Edward A. Firestone
Attorney at Law
775 Guinda St.
Palo Alto, CA 94301
Tel. No. (650) 327-0277
Cell No. (650) 269-4561

Subject: Tentative Order – Initial Site Cleanup Requirements for
1643 Contra Costa Boulevard Pleasant Hill, CA (“Site 1”)
Regional Board File No. 07S0132 (KEB)

Tentative Order – Initial Site Cleanup Requirements for
1705 Contra Costa Boulevard Pleasant Hill, CA (“Site 2”)
Regional Board File No. 07S0204 (KEB)

b) Source Area Near Manhole M46

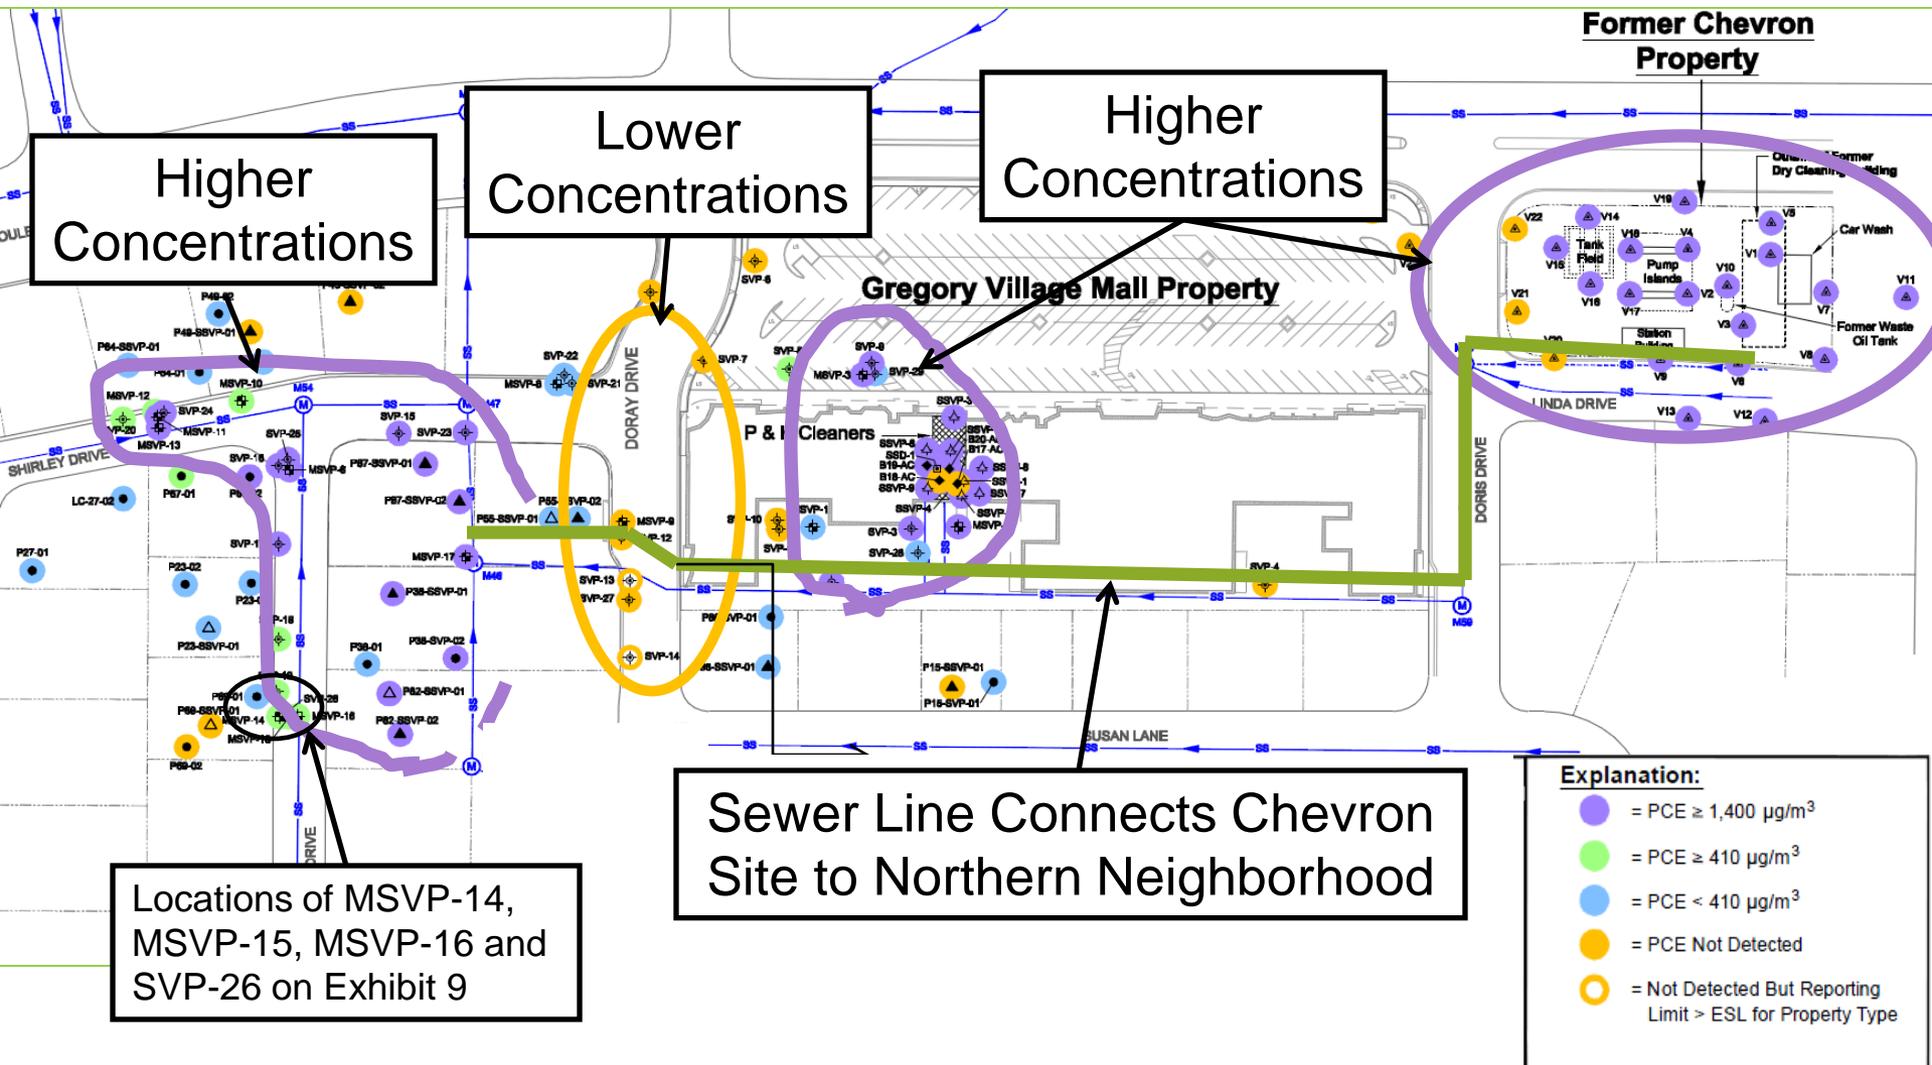
Both groundwater and soil vapor data establish that there is a source of PCE and other CVOCs in the vicinity of CCCSD manhole M46. The sanitary sewer that enters manhole M46 from the south received waste from both the Chevron Site and the P&K Cleaner Site. Also, this sewer is located at or below the water table and thus any release of CVOCs from it would result in detecting CVOCs at the highest levels in soil vapor nearest to the water table. Of the three soil vapor sample depths at MSVP-17, which is located near manhole M46, the soil vapor sample nearest to the sewer and to the water table had the highest PCE concentration. PCE was detected in a grab groundwater sample at a concentration of nearly 2,000 micrograms per liter (“ug/L”), which is the

highest PCE concentration measured to date in groundwater north of the P&K Cleaner Site. Lower PCE and CVOC concentrations near Doray Drive, i.e., between the P&K Cleaner Site and the manhole M46 area, indicate that a separate release or contribution of PCE to groundwater occurred near that manhole (Exhibit 2 attached). In addition, PCE concentrations in soil vapor are higher in the vicinity of manhole M46 (extending to the Shirley Drive and Cynthia Drive area) than in the area between manhole M46 and the P&K Cleaner Site, i.e., within the Doray Drive area (Exhibit 8 attached). The best explanation for the detections of CVOCS near M46 is that there was a CVOC release from the sewer in that area.

Separate Areas of High PCE Concentrations in Soil Vapor Indicate Separate Releases

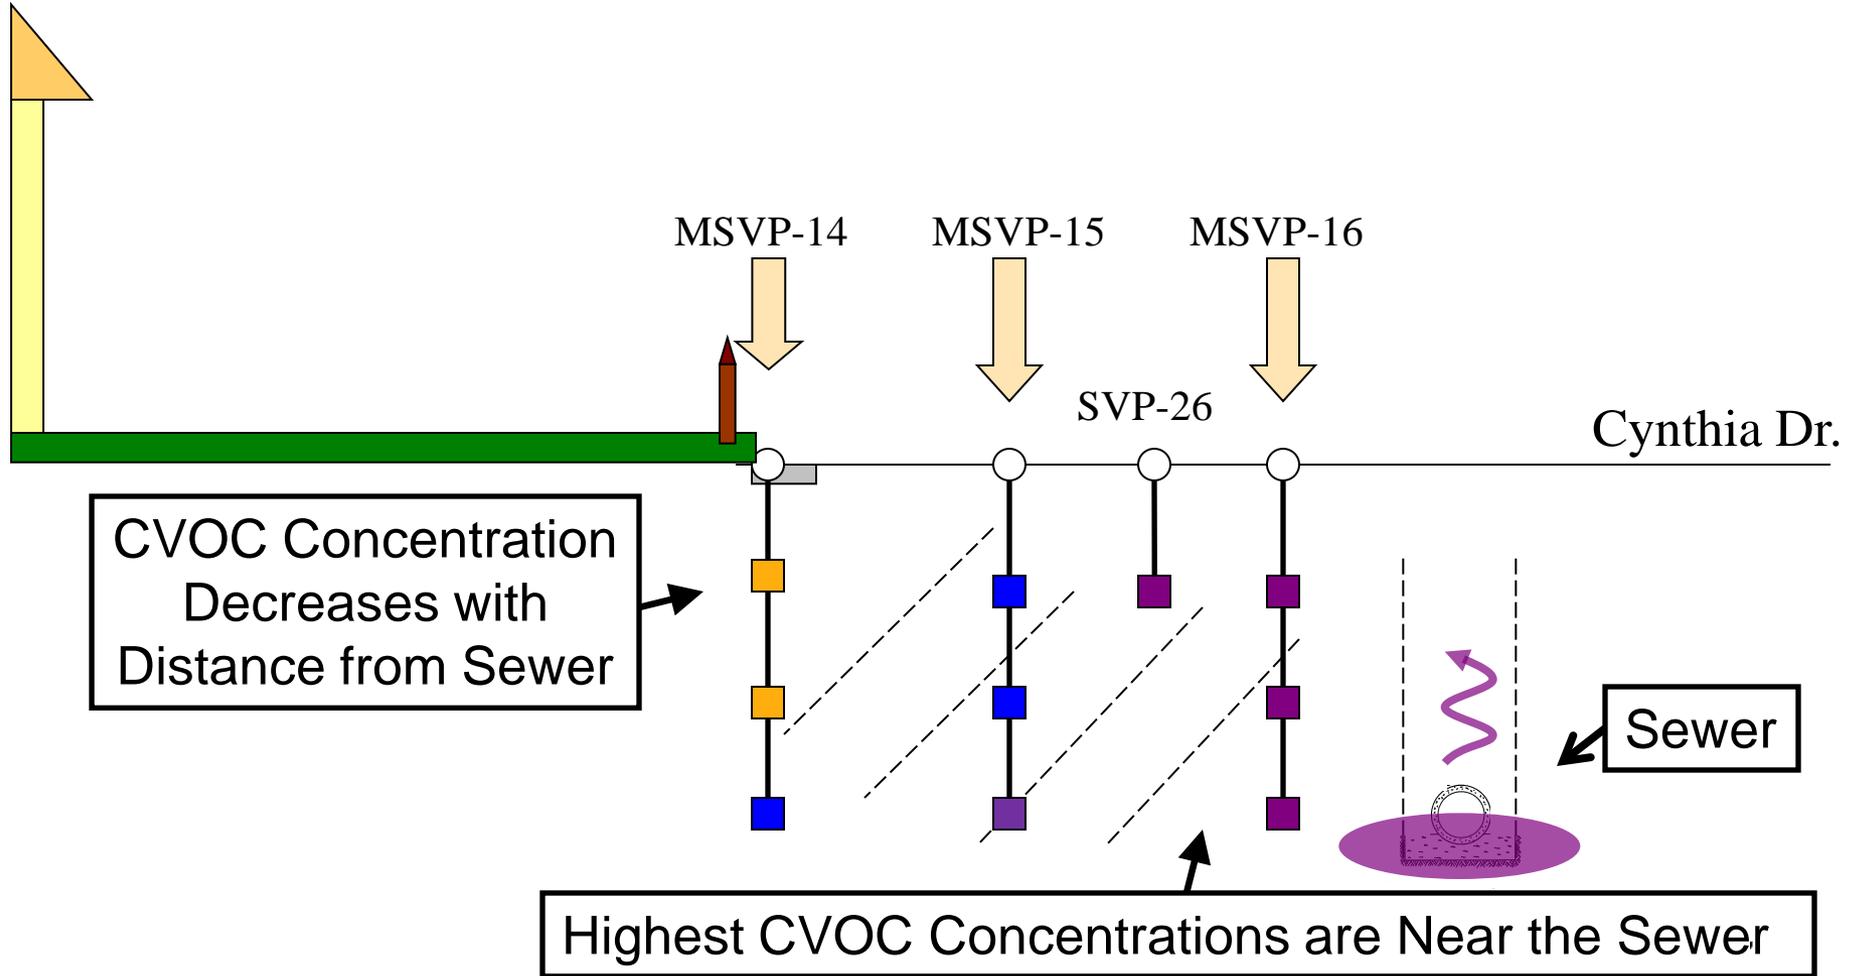
CVOC Concentrations In Soil Vapor are Highest Near the Sewer

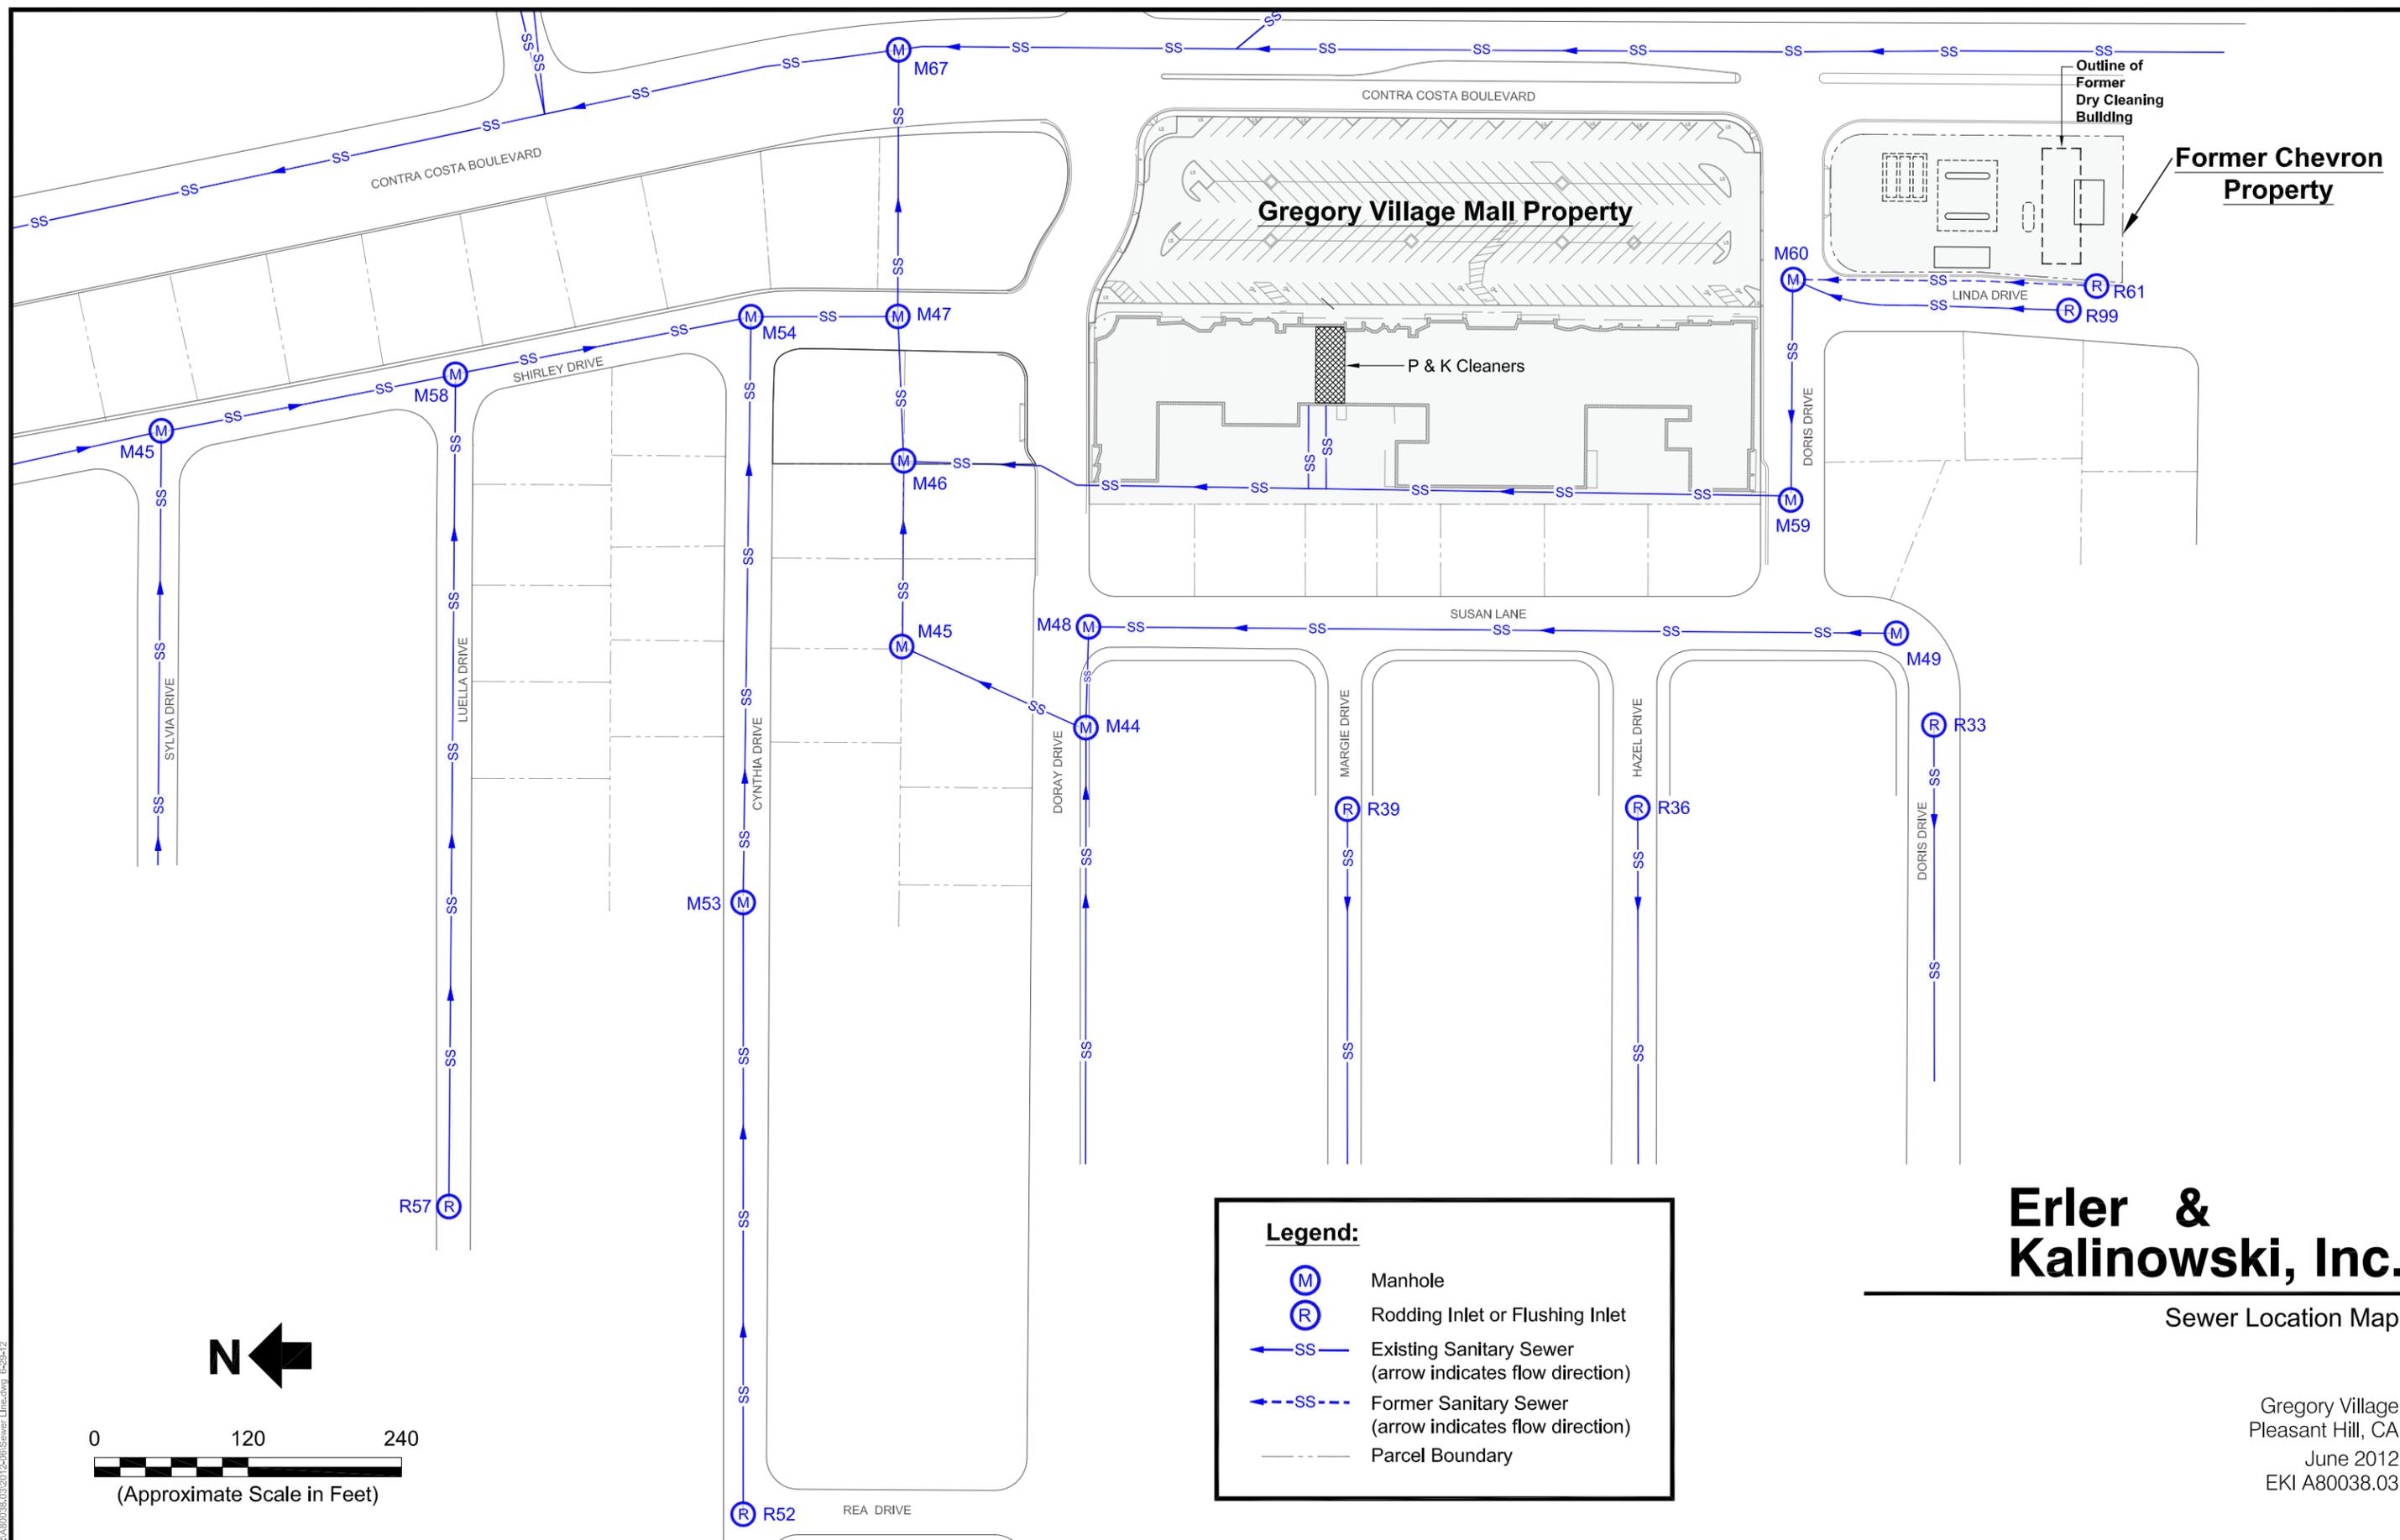
iv) *CVOC Release from Sewers Near the Intersection of Shirley Drive and Cynthia Drive (page 13, Section VI.1, first bullet)*: As previously reported to the RWQCB, investigations in the vicinity of this intersection provide evidence of a release from sewers in this area (EKI's *Off-Site Property Specific Soil Vapor and Sub-Slab Vapor Investigation Report*, dated 19 January 2011 and Exhibit 5).

demonstrate that the locations of highest vapor concentration are closest to the sewer with diminishing concentrations moving away from the sewer. If the source of the CVOC vapors were only a plume in the groundwater, equivalent CVOC levels would be detected horizontally above the groundwater across the plume. Here, however, the data correlates to a release in the middle of Cynthia Drive and the sewer line located in the middle of Cynthia Drive.

- (1) The CCCSD should investigate the occurrence of CVOC releases or migration along permeable backfill material along the sewer, which is nearly flat in this area of Shirley Drive.
- (2) The leakage of wastewater containing CVOCs from sewers and the migration of CVOC vapors from sewers is supported by the results of a multi-depth vapor sampling investigation conducted in several locations by GVP. For example, as illustrated on Exhibit 9, soil vapor samples taken on Cynthia Drive in a line perpendicular to the sewer line

Chevron Compliance Point and Only Well is NOT in the Chevron Plume

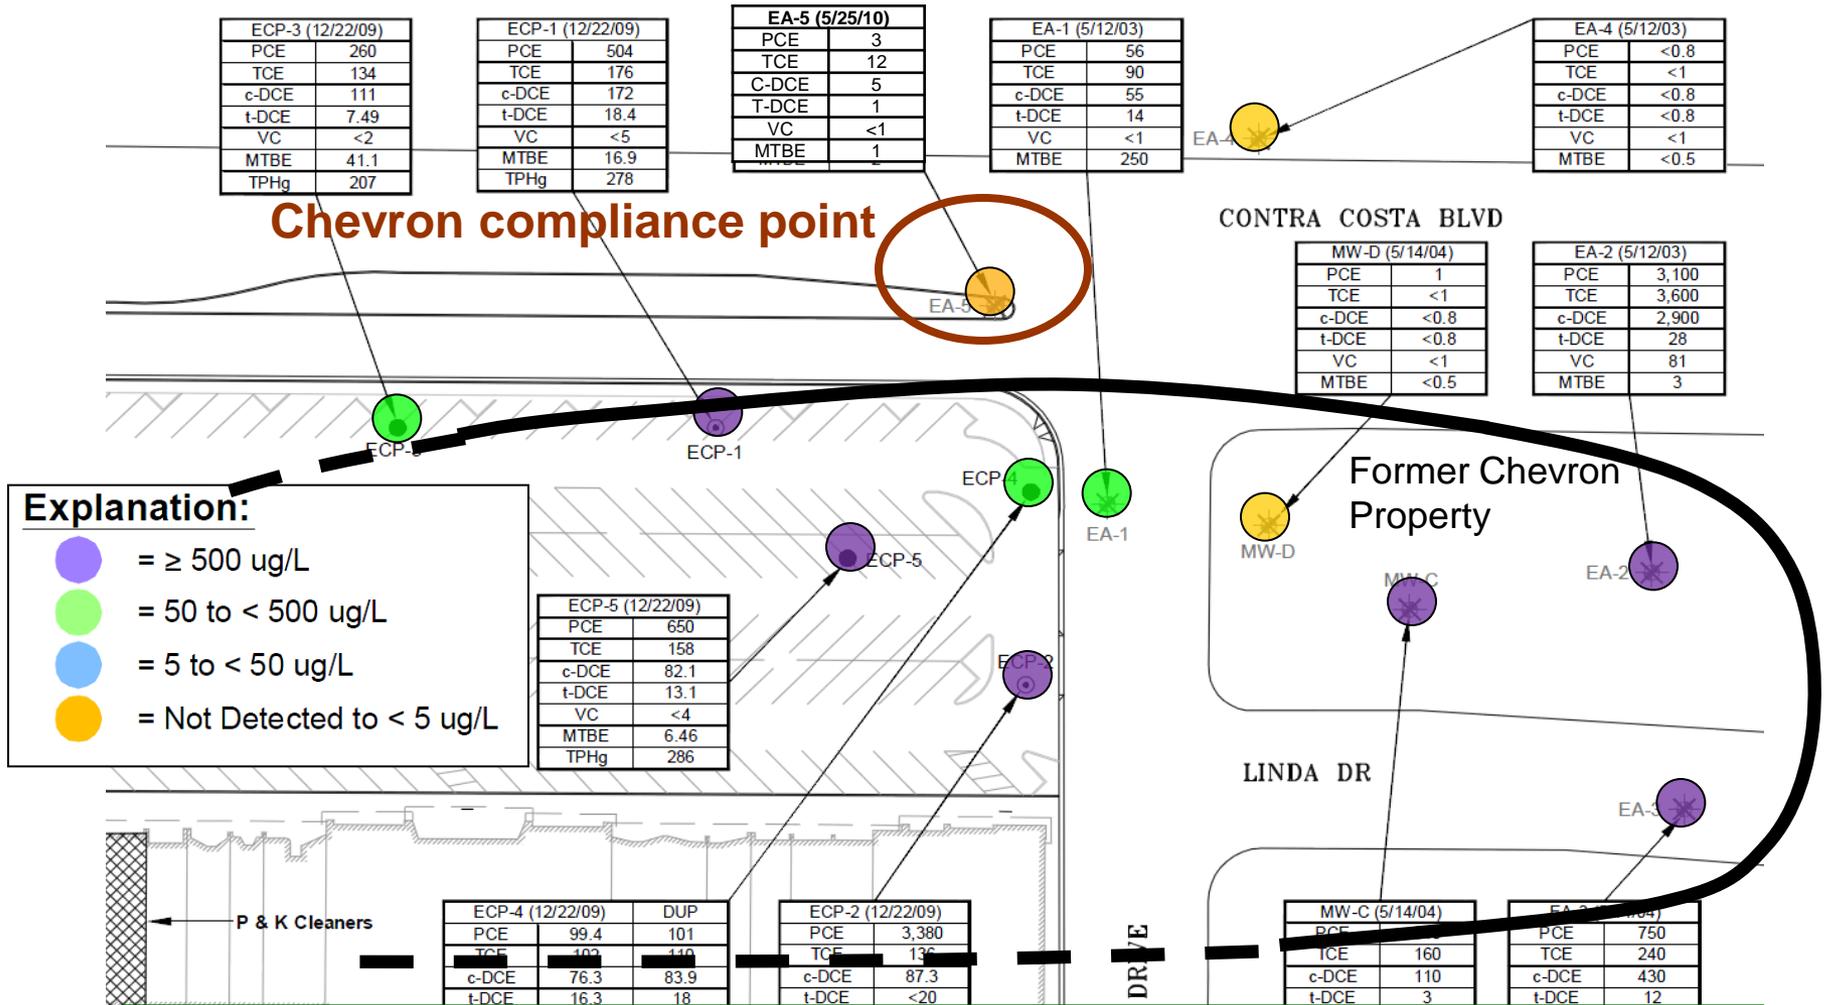
Note: Except at the Chevron compliance point (existing well EA-5), the color dots are one time grab sample locations or wells that have been destroyed by Chevron.
